Job: TH - Walled Garden Buildings

Title: Door Details - DTB7 P2
Door Type - B8
Sheet 3 of 3

Type: Building 16 & 16a

3124 762.3 P2

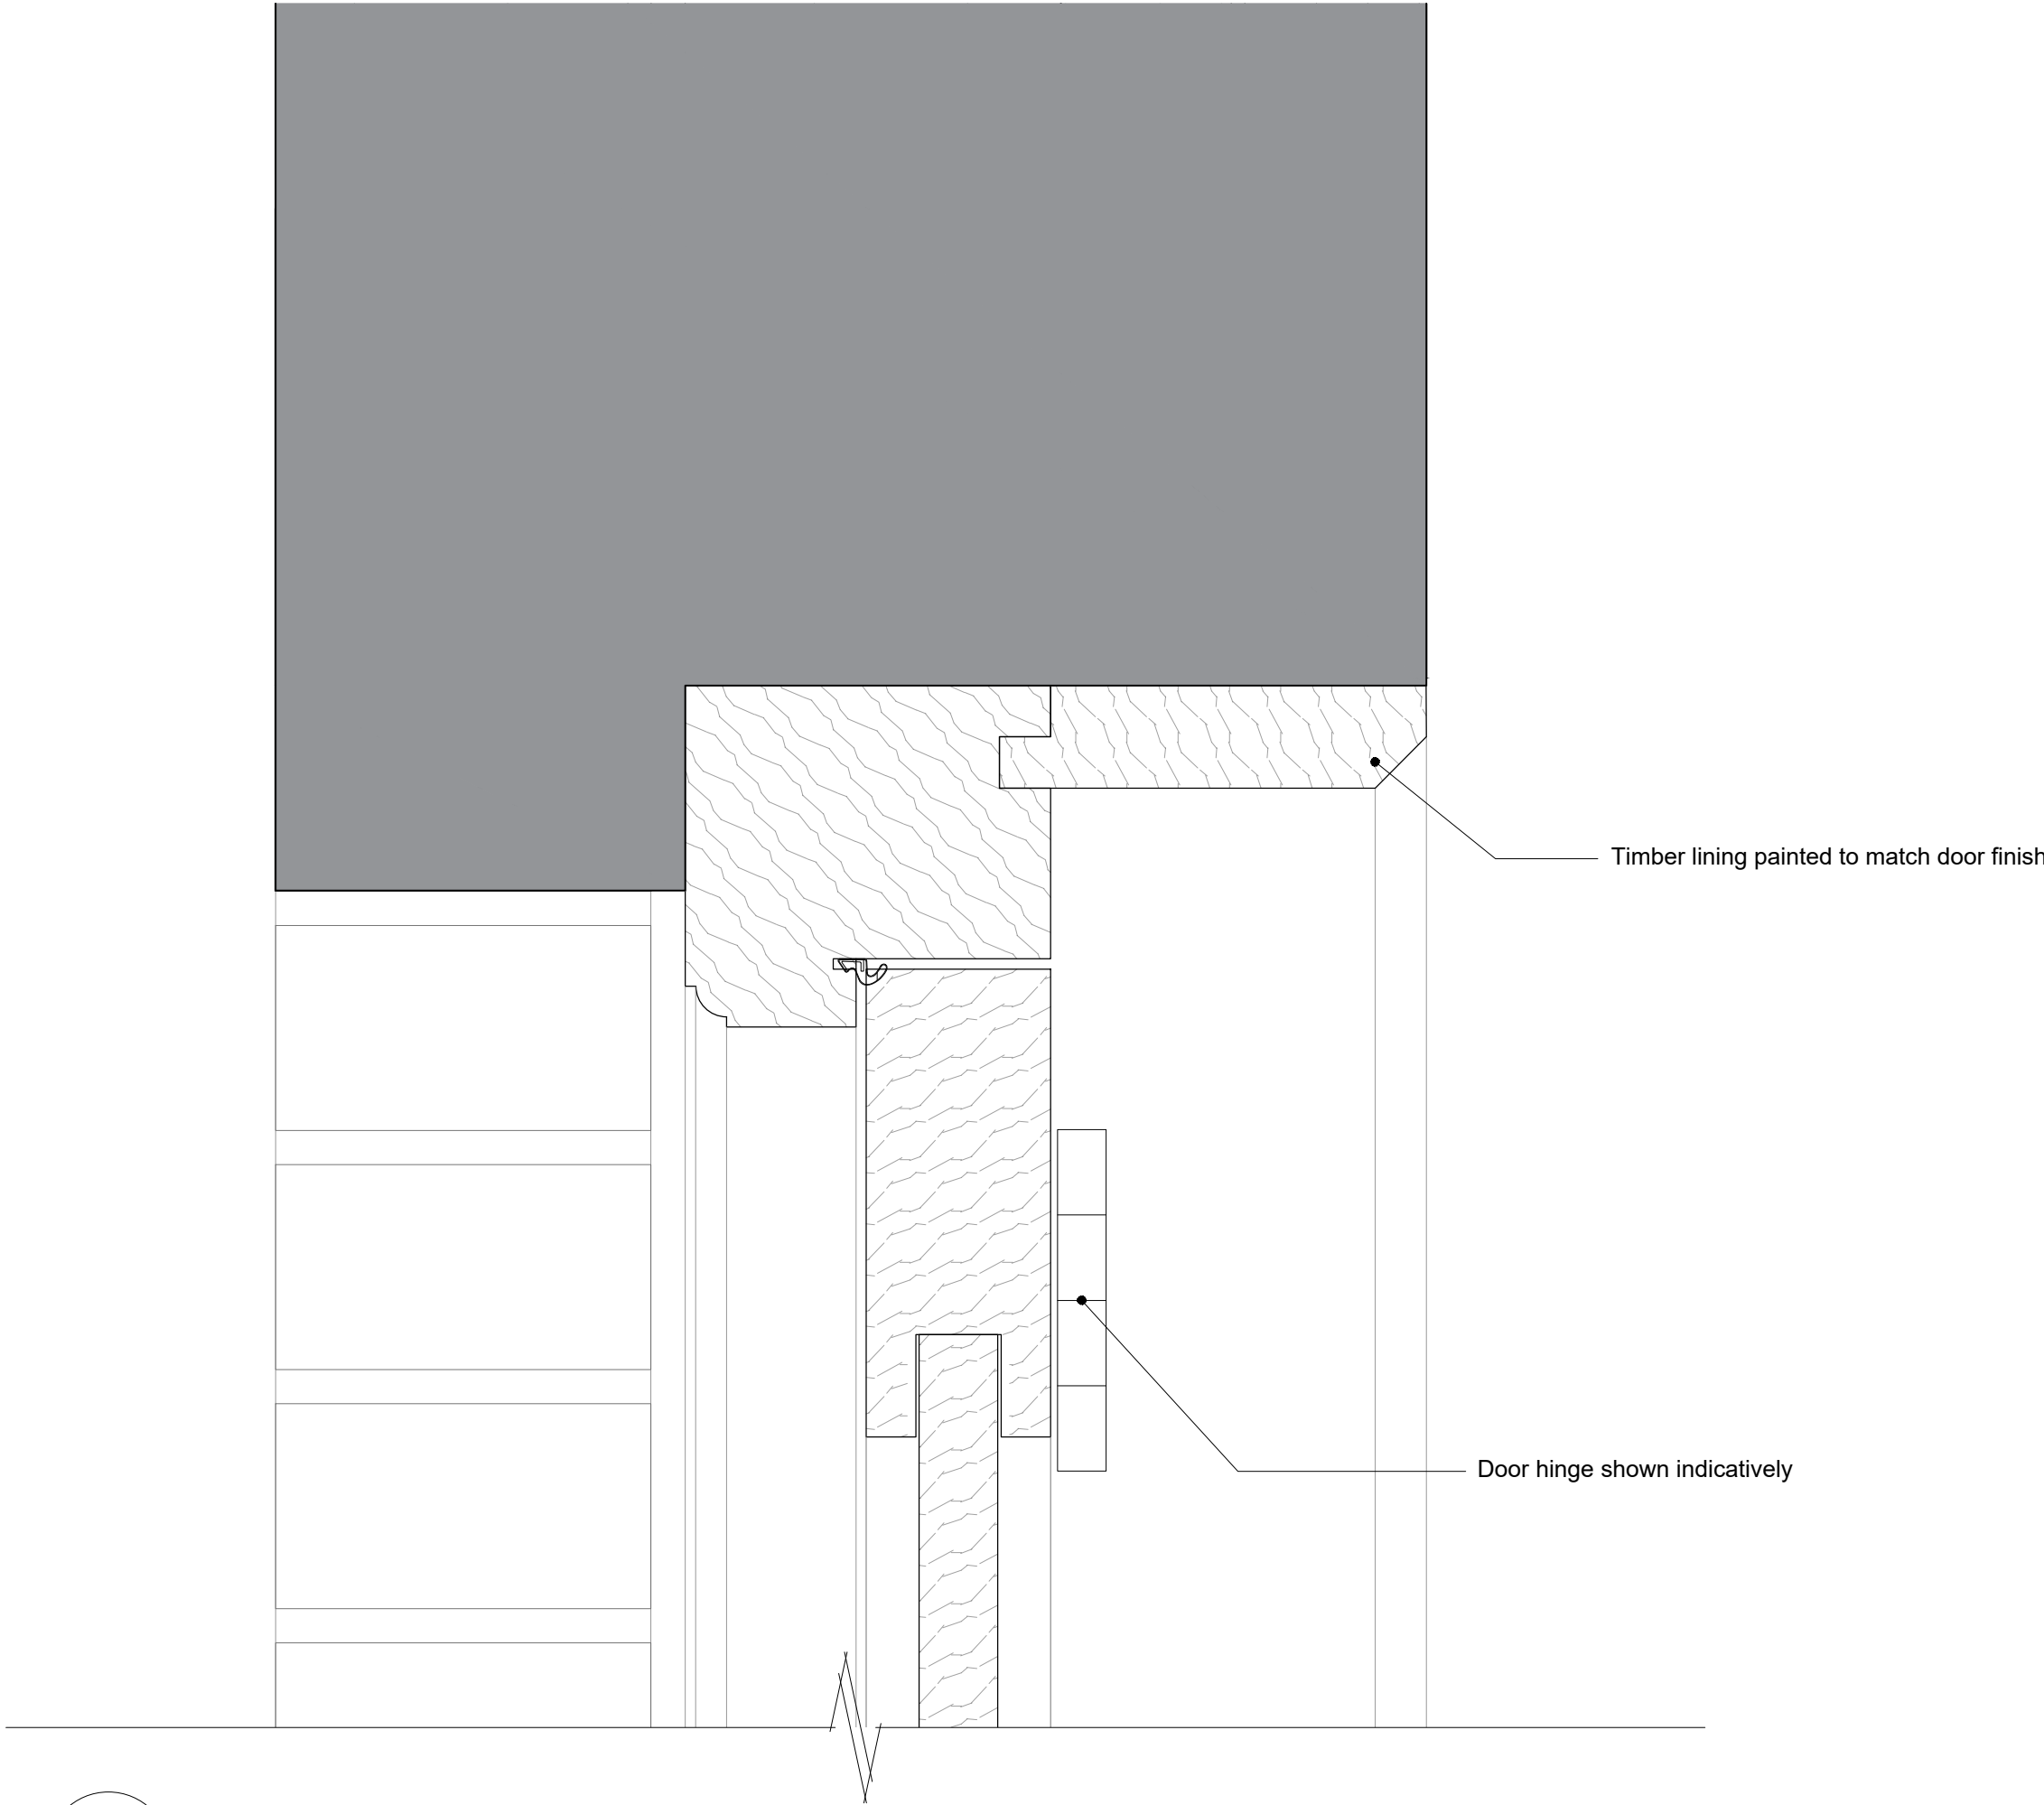
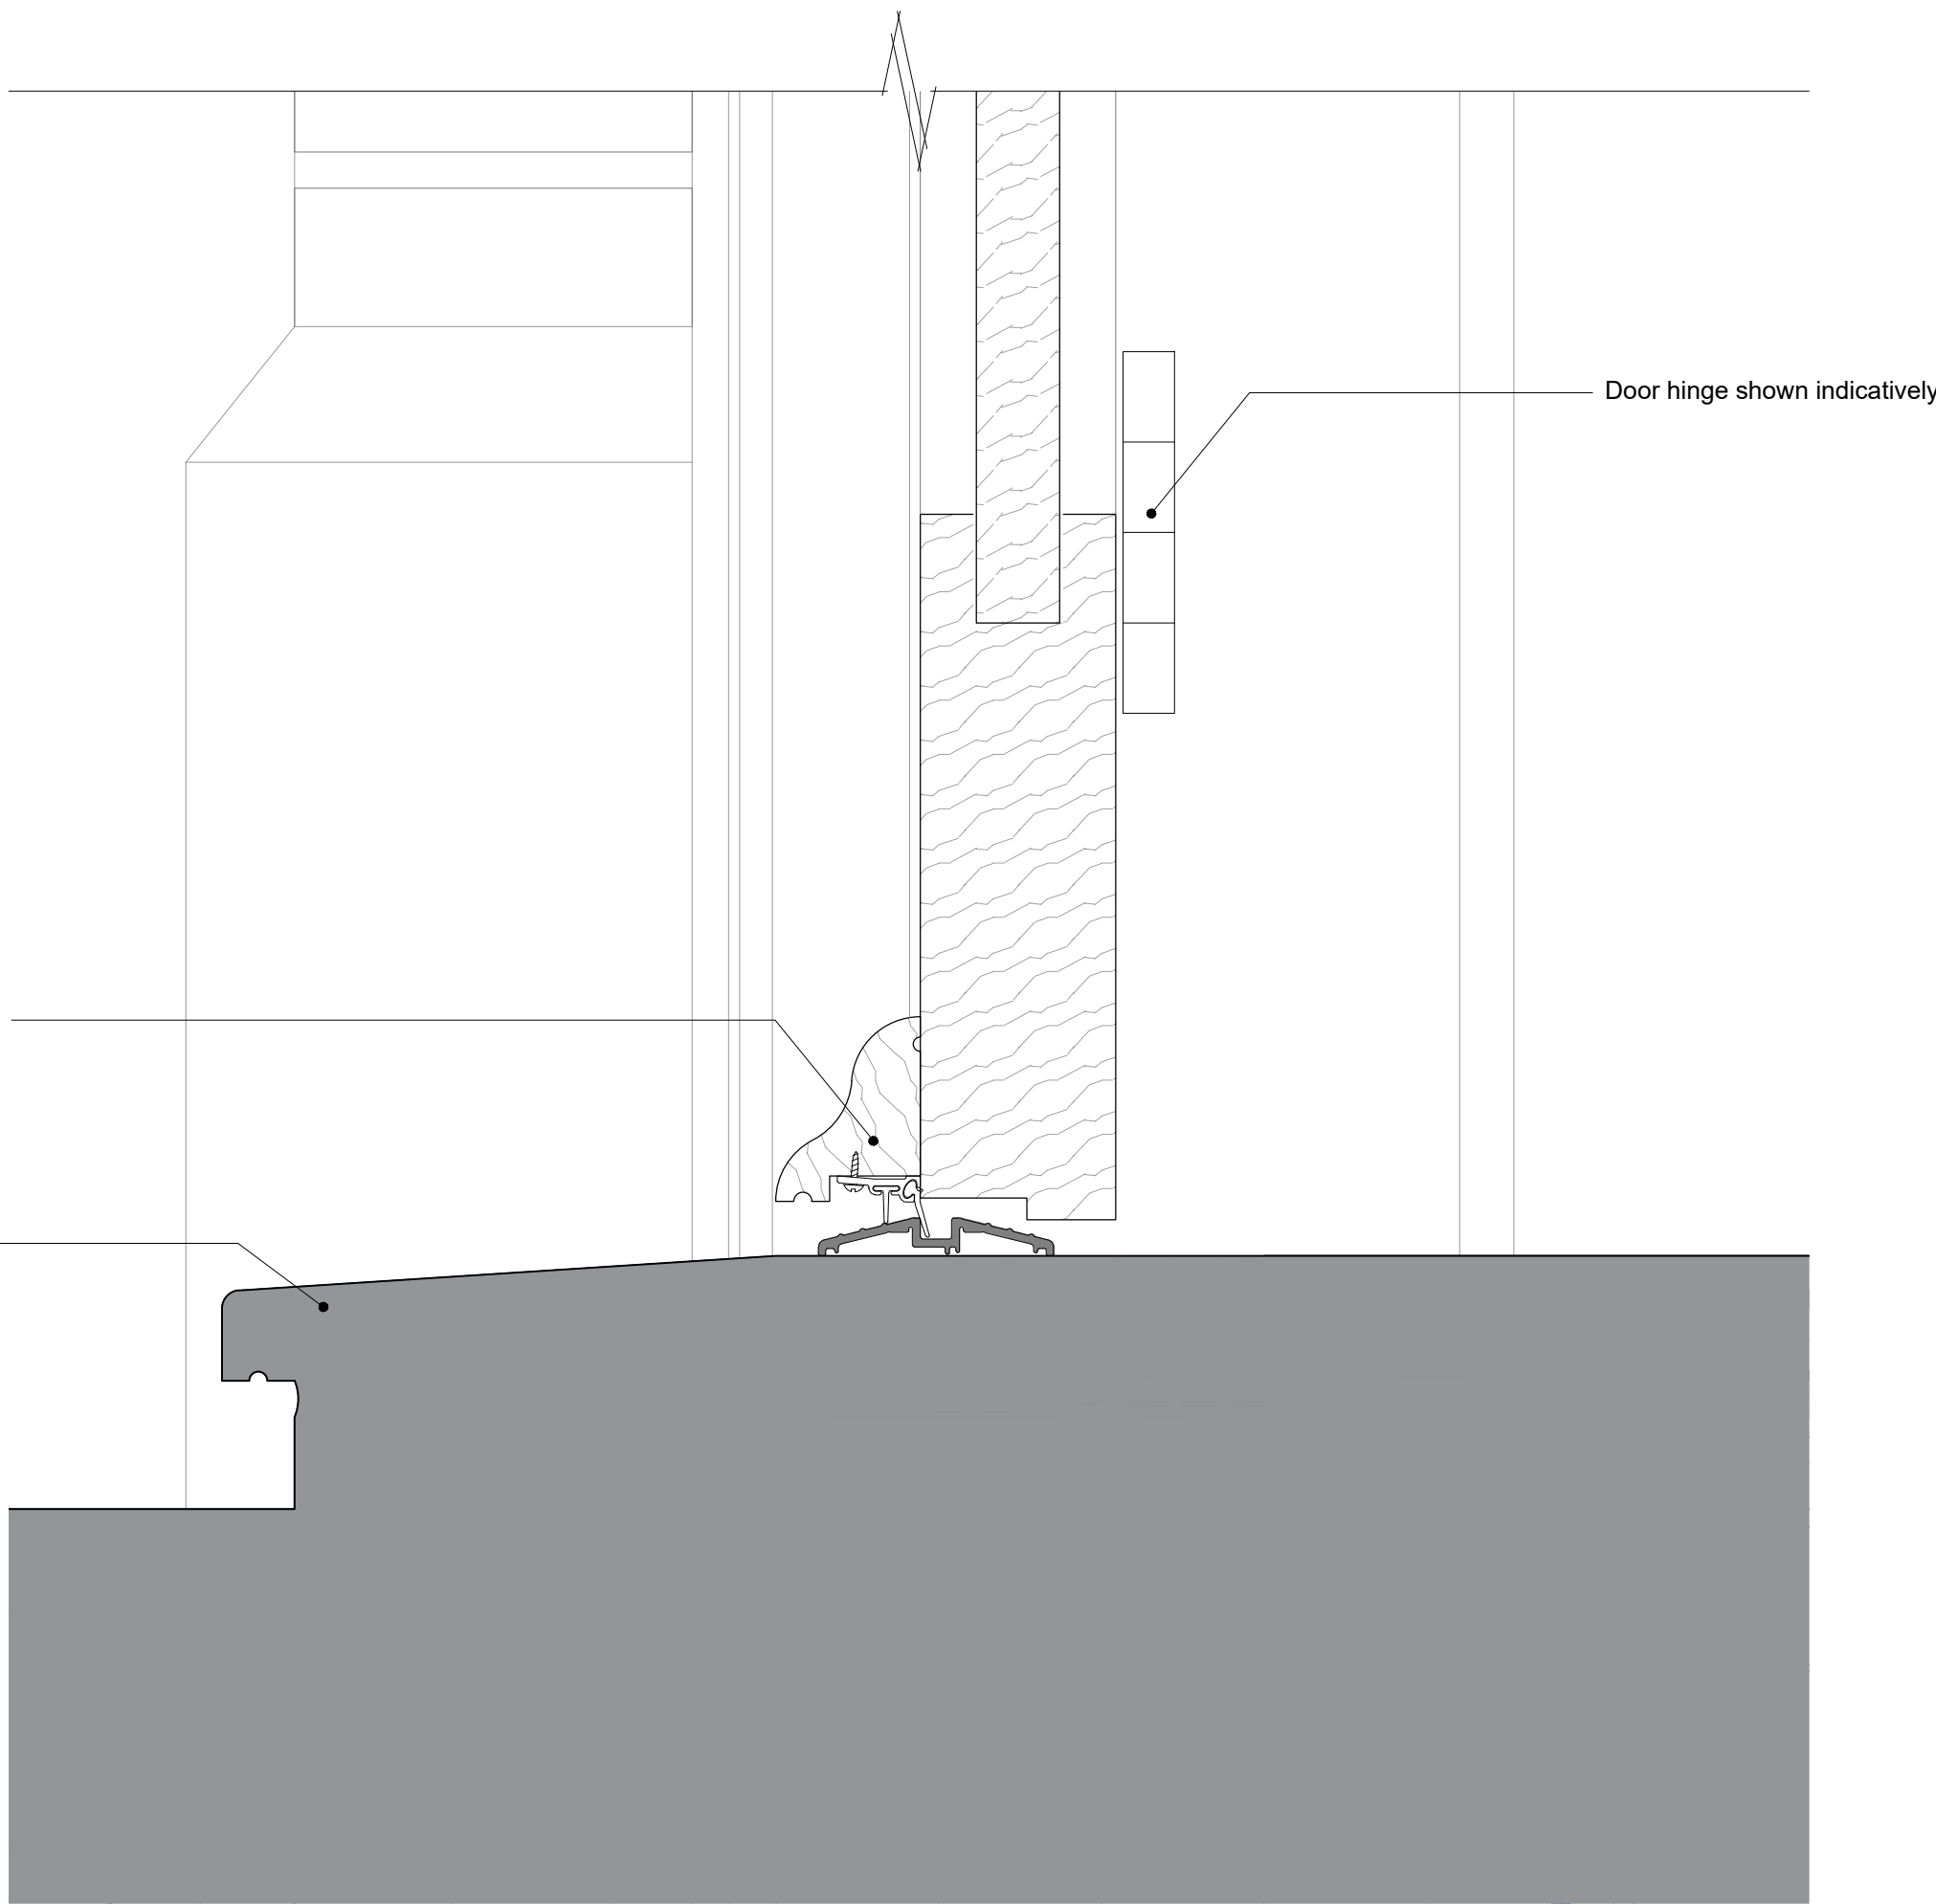
P2 Door amended to traditional timber frame and battened door with a natural stone cill following officers' comments. Scale Bar Amended. 26/03/26
P1 Initial Release dd/mm/yy
